# Product Change Notification

**Change Notification #:** 115350 - 00  
**Change Title:** Intel® Dual Band Wireless-AC 8265  
**SKUs:** 8265.NGWMG; 8265.NGWMG.NV;  
 8265.NGWMG.S; 8265.NGWMG.NVS;  
 8265.NGWMG.K; 8265.NGWMG.NVK;  
 8265.HUWMG.NV  
**PCN 115350-00, Label, Manufacturing Site  
 Label Update and Site Addition**  
**Date of Publication:** March 21, 2017

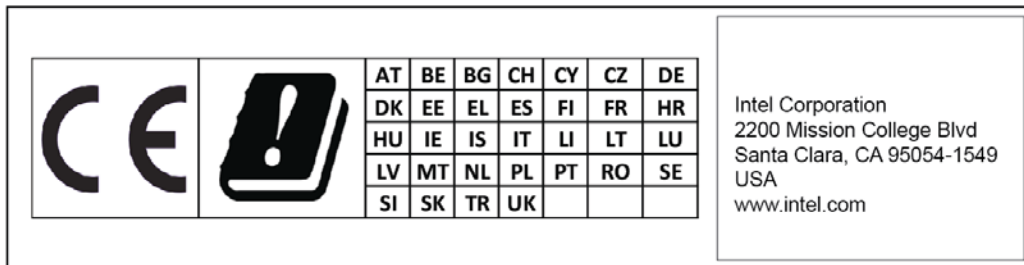
- As a result of changes decreed by the new European Radio Equipment Directive 2014/53/EU, Intel is making the following updates to all products.
  - The current CE ! Mark on the module label will be modified to remove the Alert Symbol ( ! ) following the CE mark.
  - We will be adding 2 graphics to the outer packaging to be visible by EU customs.
    - A new CE graphic:
    - The Intel Corporate address

- Intel is adding Gemtek as additional site to manufacture the modules. For those modules manufactured at Gemtek the site code on product label & disti label (FOD) will be WDM4 = CX.

The Intel Tracking number revision will be changed as follows on the following products:

SKU	Before	After
8265.NGWMG	0C	0D
8265.NGWMG.NV	0C	0D
